Access Compliance Report

Public Rights-of-Way

(Curb Ramps)

Intersection ID: 13994	Main Street: E_3RD_ST	Cross Street: S_TORRENCE_ST	Location: E
ADA ID: ADF69D3636A6	Ramp Type: Perp	Initial Pass/Fail: Fail	Overall Compliance: No
Severity Score: 10			
Codes/Mitigation Info/Possible Solution		Field Measurements/Component Compliance

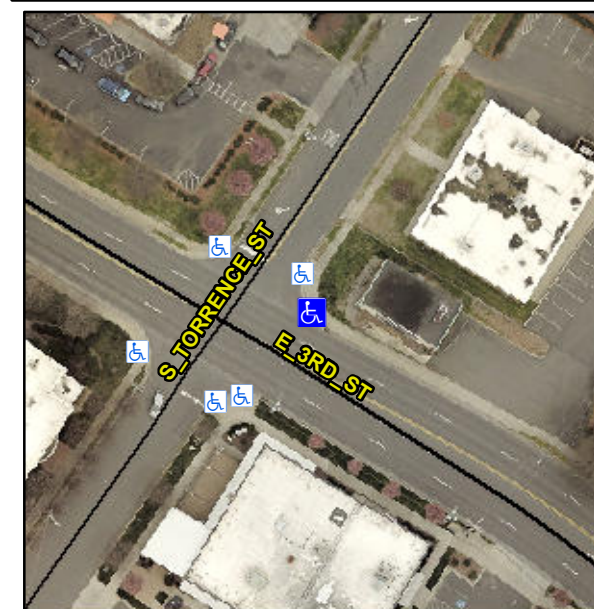
Not Found, R304.5.1, R304.5.3

Compliance	Description	Data	Compliance	Description	Data
N/A	Ramp Length (in)	71.0	Yes	Ramp Slope (%)	5.3
No	Ramp Width (in)	36.0	No	Ramp XSlope (%)	4.3
N/A	Flare Type LT	N/A	N/A	Flare Type RT	N/A
N/A	Flare Slope LT (%)	N/A	N/A	Flare Slope RT (%)	N/A
N/A	Flare Traversable LT?	N/A	N/A	Flare Traversable RT?	N/A
N/A	Landing Length (in)	N/A	N/A	DWS Provided?	N/A
N/A	Landing Width (in)	N/A	N/A	DWS Contrast?	N/A
N/A	Landing Slope (%)	N/A	N/A	DWS Length (in)	N/A
N/A	Landing X Slope (%)	N/A	N/A	DWS Full Width?	N/A
N/A	Landing Curb? (Y/N)	N/A	N/A	DWS Offset (in)	N/A
N/A	Shared Landing?	N/A			
N/A	Gutter Ponding?	N/A	N/A	Gutter Slope (%)	N/A
N/A	Gutter Lip Ht (in)	N/A	N/A	Gutter X Slope (%)	N/A
N/A	Painted X Walk1?	No	N/A	Painted X Walk2?	N/A
	X Walk 1 Direction	To SW		X Walk 2 Direction	N/A
N/A	X Walk 1 Width (in)	N/A	N/A	X Walk 2 Width (in)	N/A
	X Walk 1 Slope (%)	2.3		X Walk 2 Slope (%)	N/A
	X Walk 1 X Slope (%)	2.9		X Walk 2 X Slope (%)	N/A

Remove & Replace Entire Ramp.
